HILLSBOROUGH RIVER DAM
DIAGNOSTIC ASSESSMENT WORKSHOP PROCEEDINGS
24 and 25 September 2013

Prepared for: City of Tampa Water Department

Prepared by: Francisco Silva - Tulla, Sc.D., P.E.
Consulting Civil Engineer
GeoEngineering & Environment

24 February 2014

ELEVATION- UPSTREAM FACE
1944/45 CONSTRUCTION PRE-1944 CONSTRUCTION

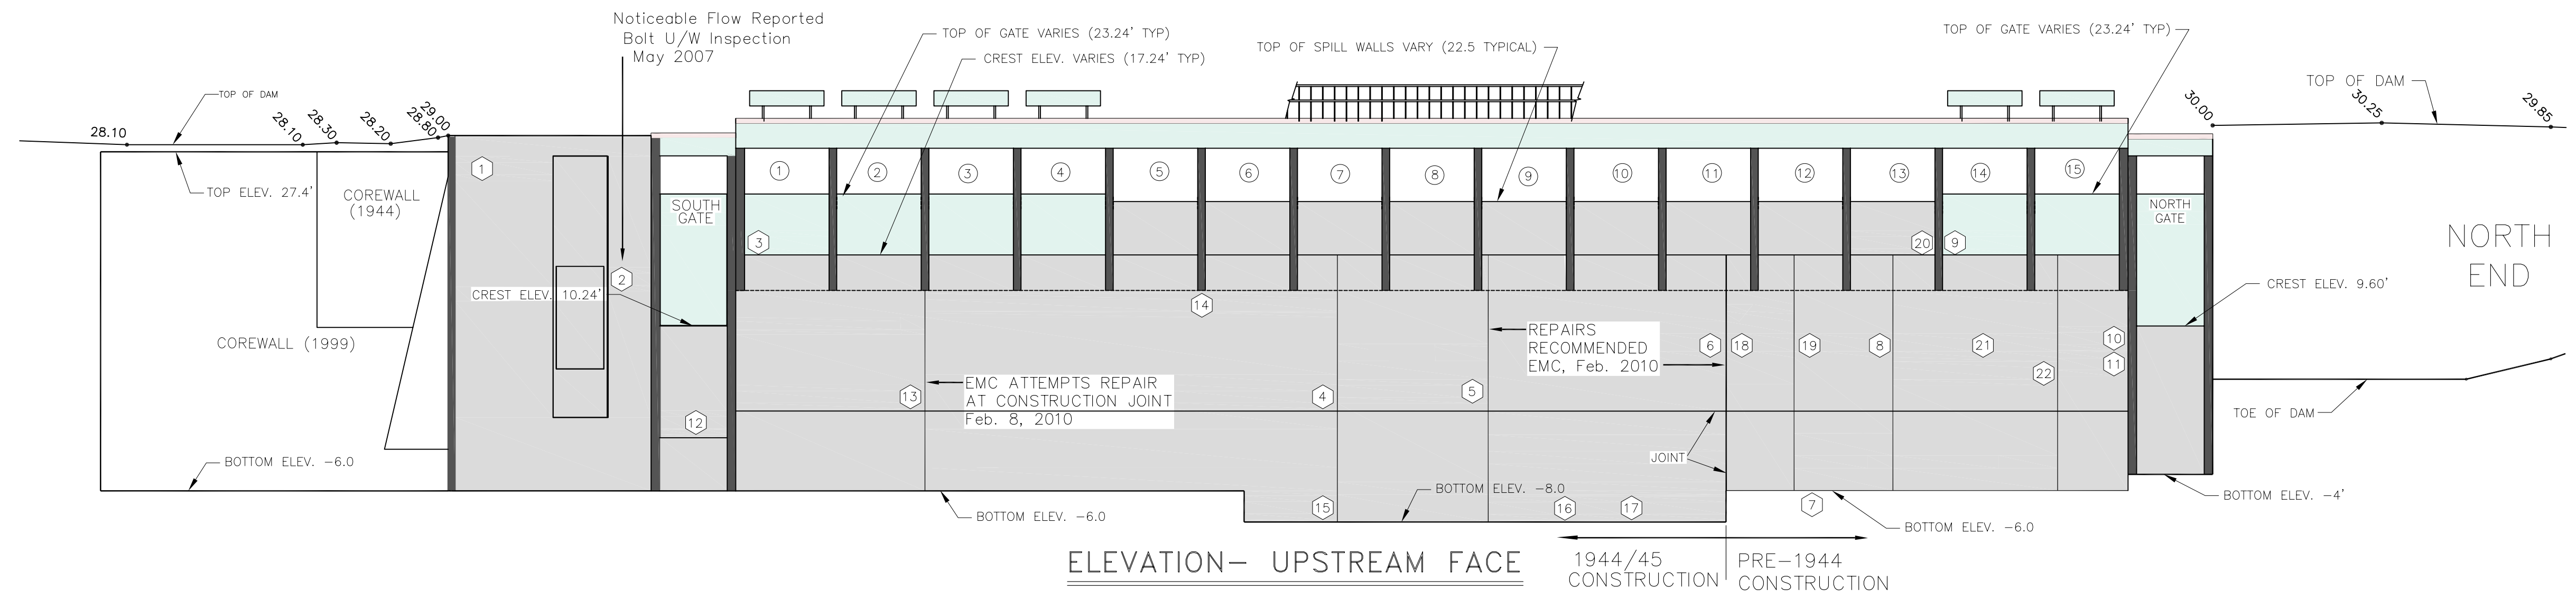
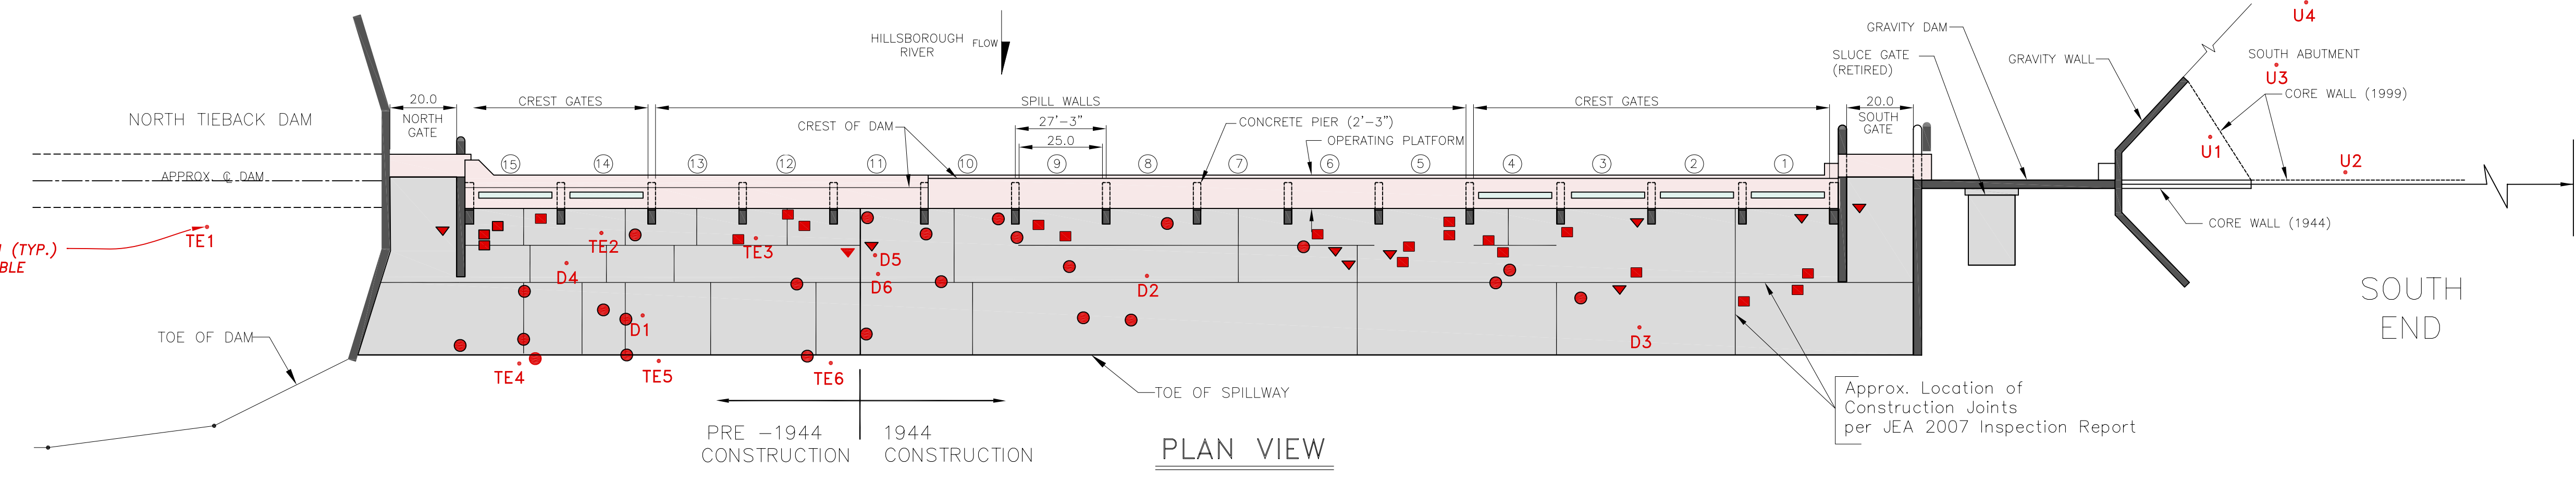
- b. **Concrete Spalling** – Repair of spalled concrete along the concrete gravity dam. The assessment team concluded that the surface spalling did not present a performance issue for the massive concrete dam and any decision regarding future repairs should be based on aesthetic considerations.
